# UNITED STATES PATENT AND TRADEMARK OFFICE

APPLICATION NO.	FILING DATE	FIRST NAMED INVENTOR	ATTORNEY DOCKET NO.	CONFIRMATION NO.
10/677,282	10/03/2003	Noritaka Okuda	3718-0105P	9656
2292 7590 08/16/2007 BIRCH STEWART KOLASCH & BIRCH PO BOX 747 FALLS CHURCH, VA 22040-0747			EXAMINER CHENG, PETER L	
			ART UNIT 2625	PAPER NUMBER
			NOTIFICATION DATE 08/16/2007	DELIVERY MODE ELECTRONIC

**Office Action Summary**

## DETAILED ACTION

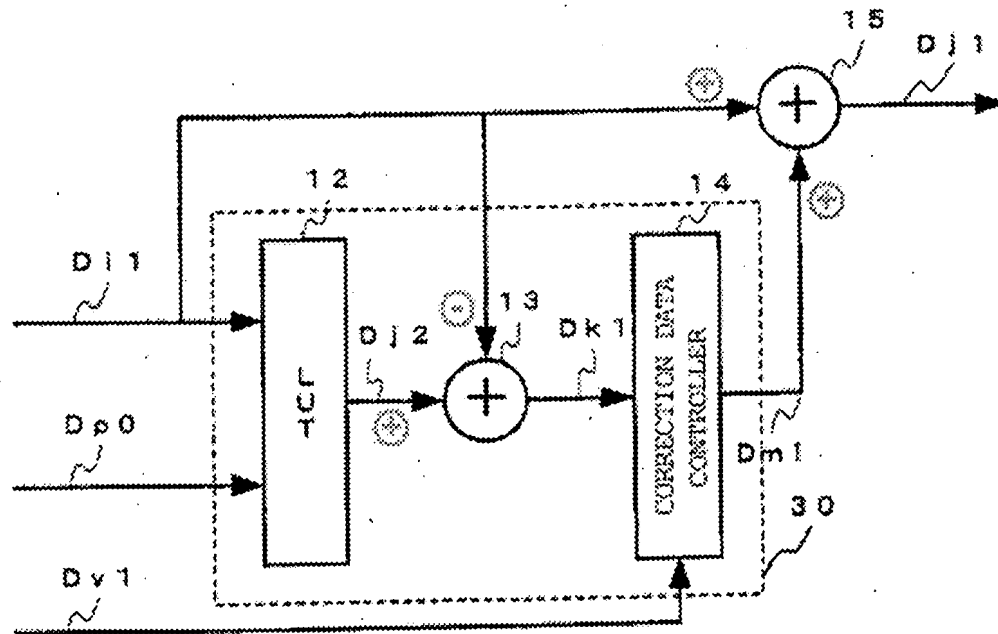
- **Fig. 1:** the specification [e.g., **page 6, lines 21, 29**] refers to the "Frame Data Correction Device" as reference number **3**; the specification [e.g., **page 5, line 4**]a/ so refers to the "Frame Data Correction Device" as reference number **10**;

**Fig. 1** cites, **10 FRAME DATA CORRECTION DEVICE**; if applicant intended to associate reference number **3** with the "Frame Data Correction Device", the citation should be changed to **3 FRAME DATA CORRECTION DEVICE**;

*However, for the purpose of claim interpretation, it is assumed that applicant intended to cite reference number **10** as the "frame data correction device" comprising a "correction data output device" (reference number **30**).*

Fig. 11

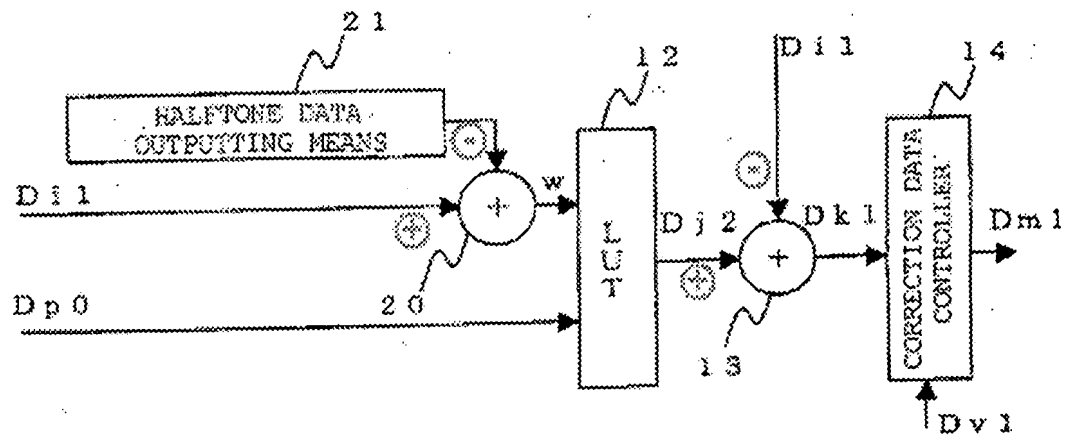
- **Fig. 11:** the specification defines "w" as being equal to "Di1" minus the "halftone data"; "The subtracter 20 subtracts the ... halftone data from the ... object frame data Di1 and outputs a signal ... referred to as a gray-level signal w"; **page 17, lines 23 – 27;**

similarly, suggest adding "polarity signs" at adders 13 and 20 as shown below:

Fig. 13

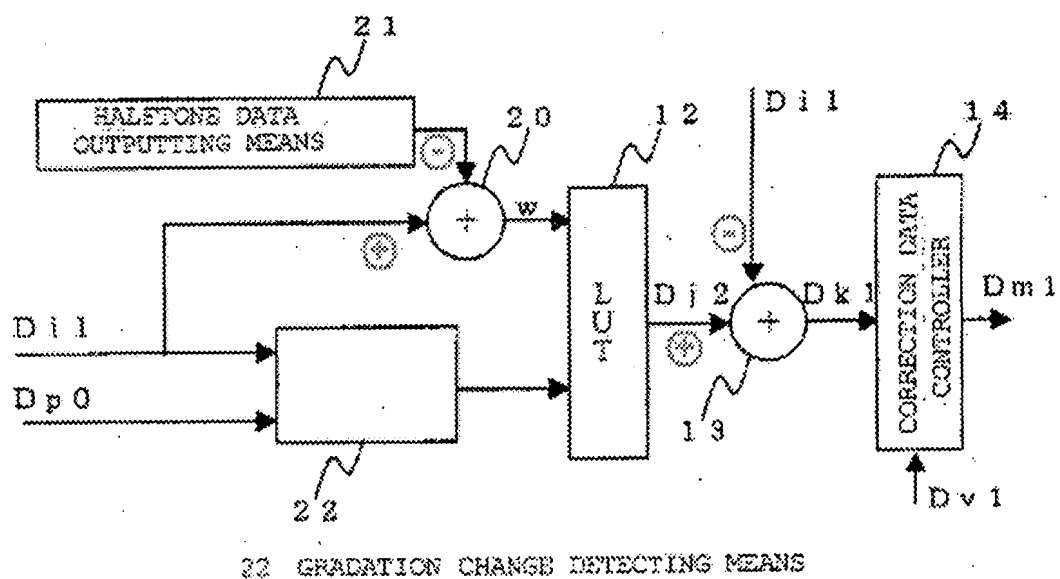
- **Fig. 13:** similarly, suggest adding "polarity signs" at adders 13 and 20 as shown below:

Fig. 17

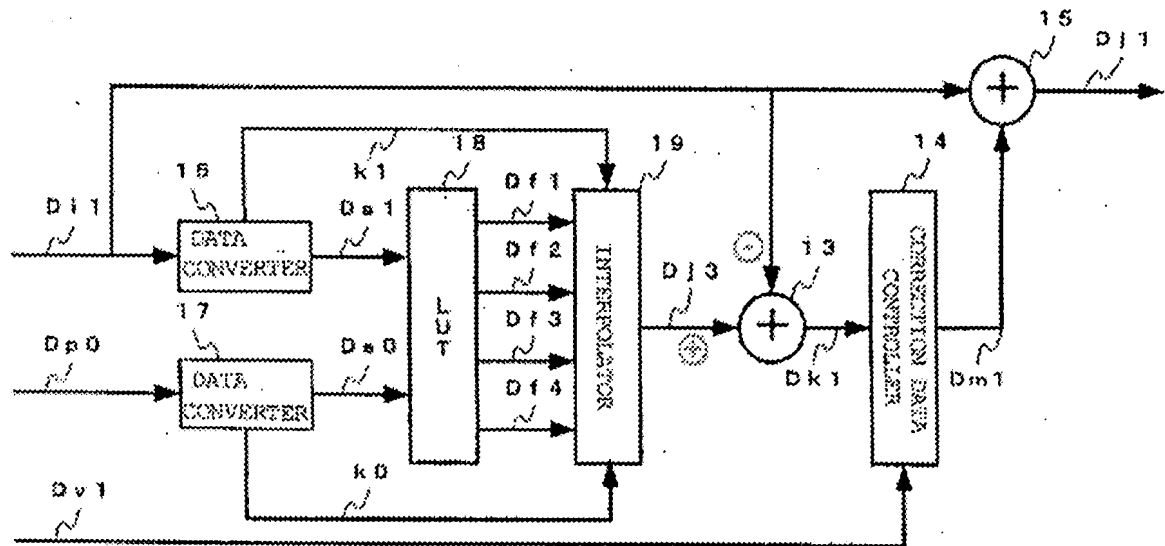
- **Fig. 17:** similarly, suggest adding "polarity signs" at adder 13 as shown below:

2. The drawings are objected to as failing to comply with 37 CFR 1.84(p)(5) because they do not include the following reference sign(s) mentioned in the description: **Fig. 17** reference number **31** (correction data output device) as cited on **page 24, lines 18, 22, 29** and **page 25, lines 1 - 2**. Corrected drawing sheets in compliance with 37 CFR 1.121(d) are required in reply to the Office action to avoid abandonment of the application. Any amended replacement drawing sheet should include all of the figures appearing on the immediate prior version of the sheet, even if only one figure is being amended. Each drawing sheet submitted after the filing date of an application must be labeled in the top margin as either "Replacement Sheet" or "New Sheet" pursuant to 37 CFR 1.121(d). If the changes are not accepted by the examiner,

- **Page 24, lines 18, 22, 29; page 25, lines 1 - 2:** the reference number **31** associated with the “correction data output device **31**” is not shown in **Fig. 17**; since reference number **30** was previously associated with a “correction data output device”, applicant may have intended to cite reference number **30** instead of **31**;
